Alton Advanced Energy Recovery Facility Regulation 25 Submission

Representations on behalf of No Wey Incinerator

February 2021

Representations on Alton Advanced Energy Recovery Facility
Regulation 25 Submission

Figure 2: Extract from Tolvik Analysis

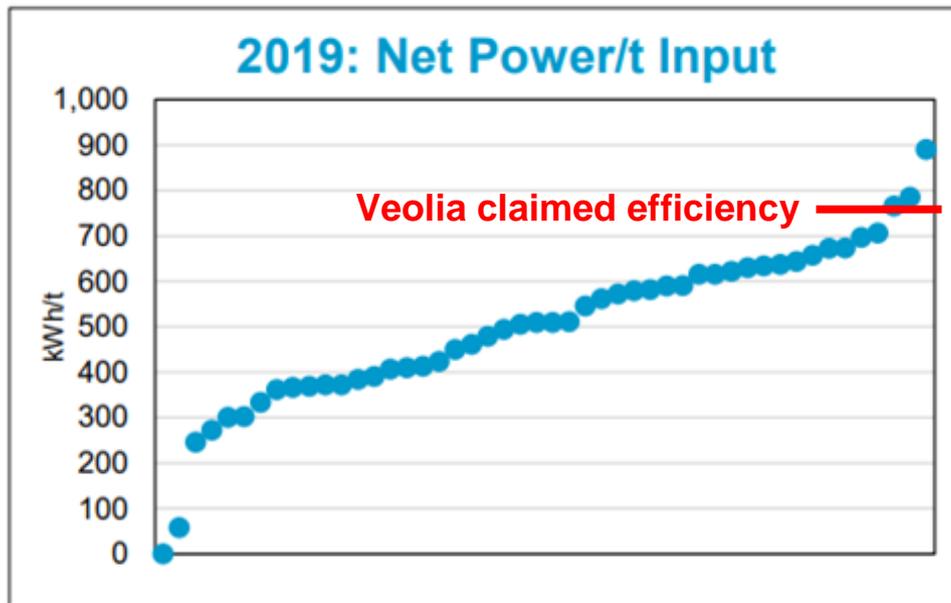
1.9 The applicant assumes 750 kWh/tonne of waste input (330,000 tonnes of waste burnt to generate 247,500 MWh of electricity), which using Tolvik Consulting 2019 figures would make the AAERF the third most efficient EFW plant in the UK. This would include plants that burn specialised Refuse Derived Fuel, and 40% above the UK average, as shown by the graph in Figure 2. No evidence has been provided to justify this.

1.10 In comparison, the performance of Hampshire's existing ERFs have a performance in electricity generated per tonne of waste incinerated between 367 and 582 kWh/tonne in 2018 and 2019 (see Appendix A1). The average is 448 kWh/tonne.
